**Just Transition Wakefield. Detailed submission, 22/02/2023.**

**Drax Bioenergy with Carbon Capture and Storage, PINS Reference: EN01012**

**COASTAL RISK SCREENING TOOL**  
**LAND PROJECTED TO BE BELOW ANNUAL FLOOD LEVEL IN 2050**  
 Explore sea level rise and coastal flood threats by adjusting the controls below.

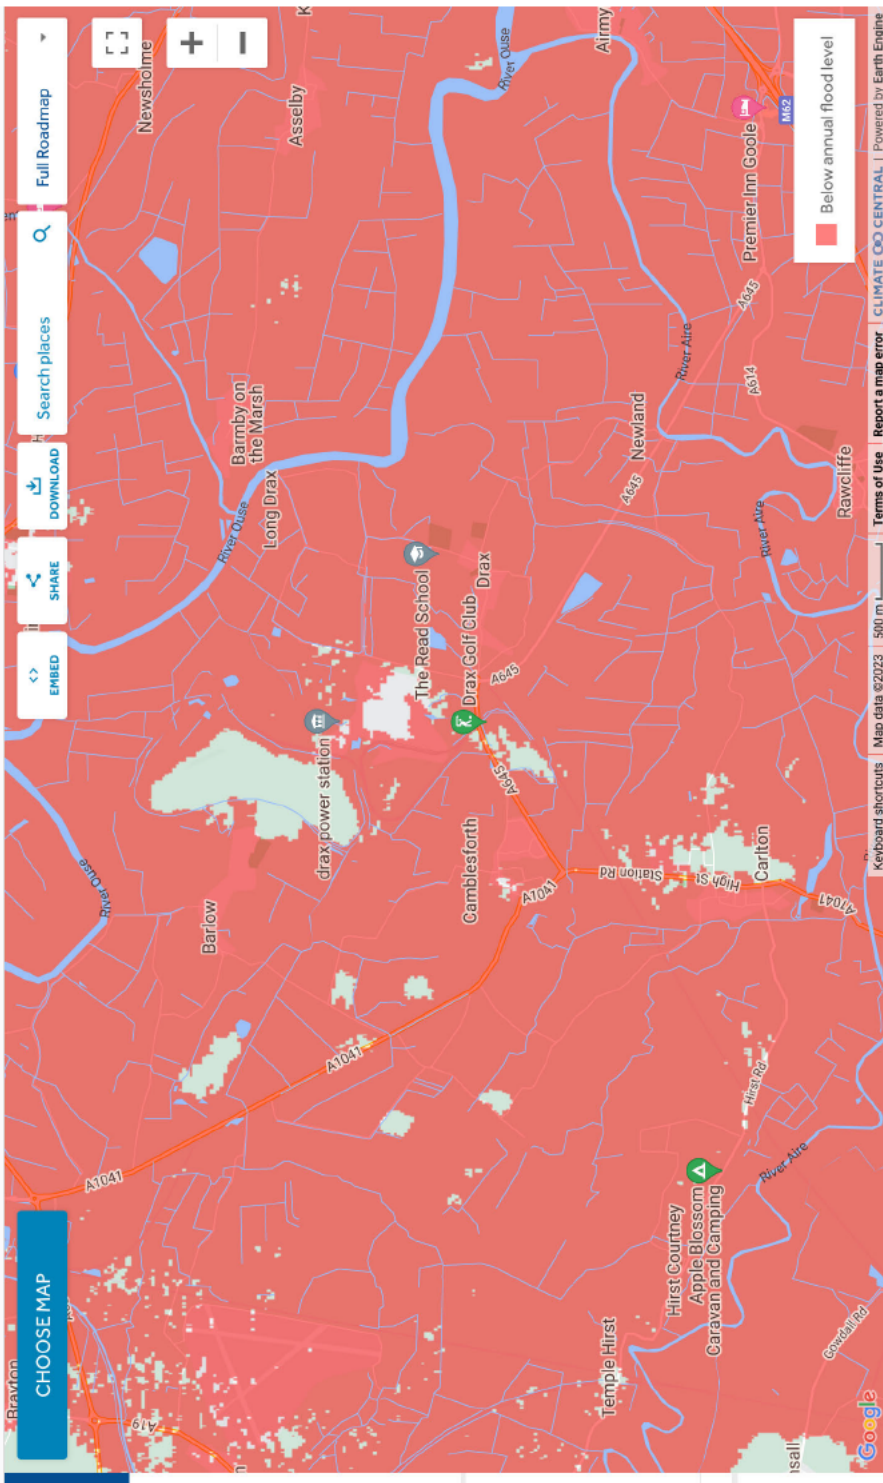
3.2 Flood Risk. We submitted evidence on flood risk at deadline 1. Below is a straightforward projection for annual flood risk by 2050, based on “current” trajectories. (The current trajectory is based on IPCC data from 2021. It is known that IPCC data is 12 to 24 months old by the time it is reported, and that new evidence of accelerating sea level rise and ice melting were released in the autumn of 2022). Therefore, the projection below is NOT a carefully selected, extreme risk scenario but a relatively modest reflection of risk. The next paragraph provides the information and parameters for the map below. The map was accessed from the website Climate Central. The parameters used in the creation of this map are in the following paragraph, 3.2.1

3.2.3 From the above evidence, we are clear in our expectations that whether this proposal is consented or not, by 2050, Drax Power Station and its surroundings can expect to be flooded every year on average. This includes the connecting rail network. In fact, on current trends, we expect the situation by 2050 to be worse than these projections.

Figure 1

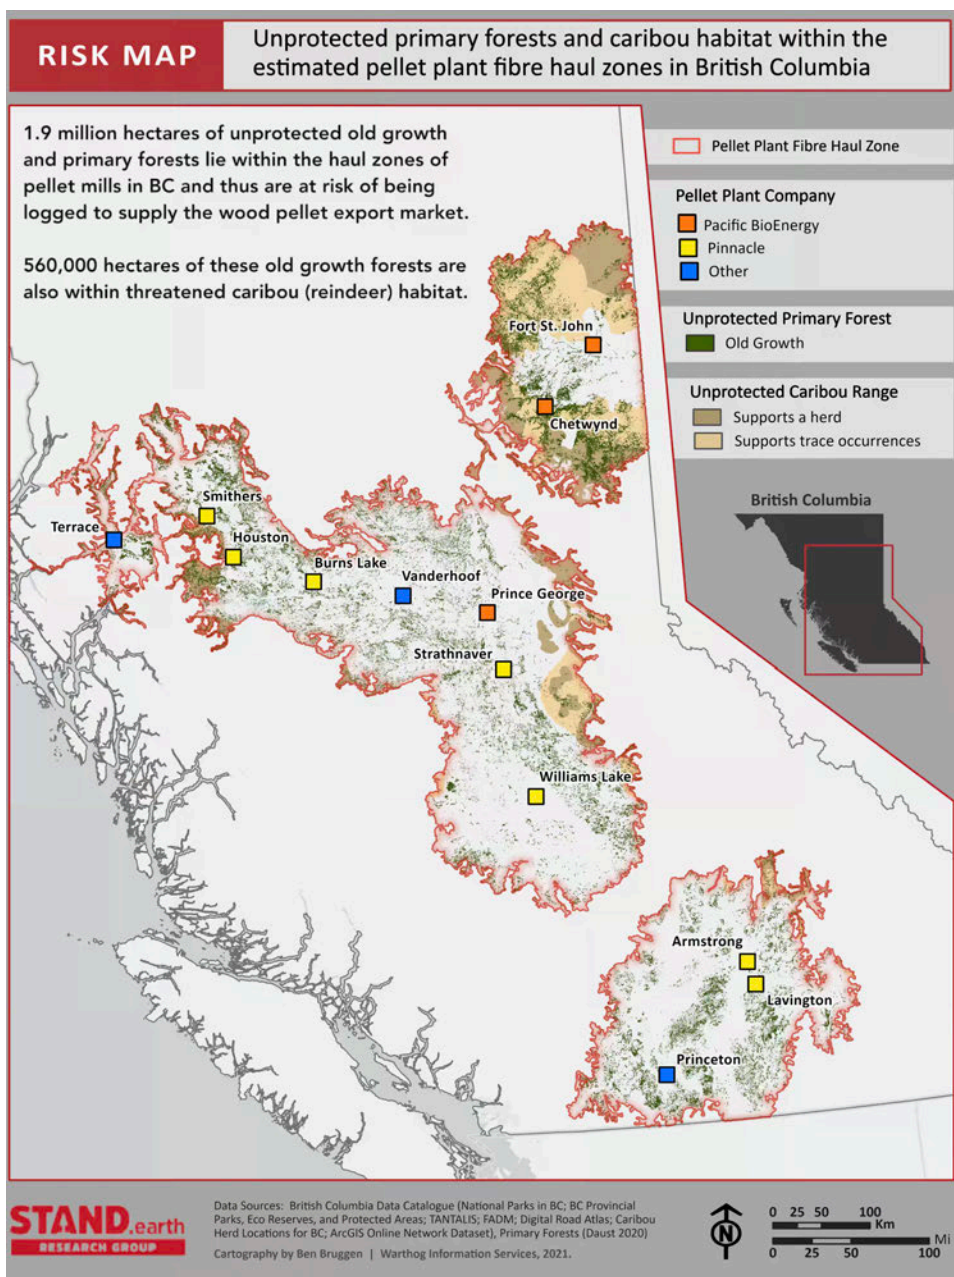
how the logging areas overlap with Caribou herd ranges. Caribou are a protected species, and most at risk from shrinking **and fragmented** habitat. It is well known that logging in blocks fragments habitat. The report was updated in 2022 with a map (fig 2 below) showing the overlap between logging areas and caribou herd ranges. The original report can be accessed here: [REDACTED]

[REDACTED]. It is our view that this evidence not only questions the sustainability of some of Drax’s Canadian imports, but also the security of supply – it is not unreasonable to suppose that legislation or regulation will follow to protect the Caribou herds. Please note that Drax now owns the Pinnacle plants.
